SERVICE BULLETIN REFRIGERATION BUILT IN

Combi bottom frost free - cracking noise

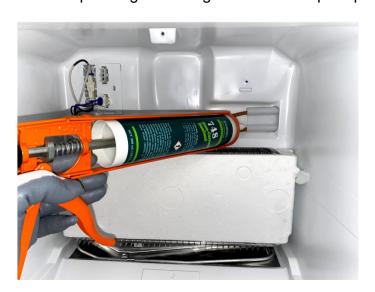
Noise in appliances equipped with a freezer cold module (freezer battery with fan and heating element).

CAUSE:

The noise comes from the plastic assembling guide used for the pipe. This was introduced in production in week 29/2019.

Seal the plastic guide using Silicone with spare part 4055071353 -Sealing compound.
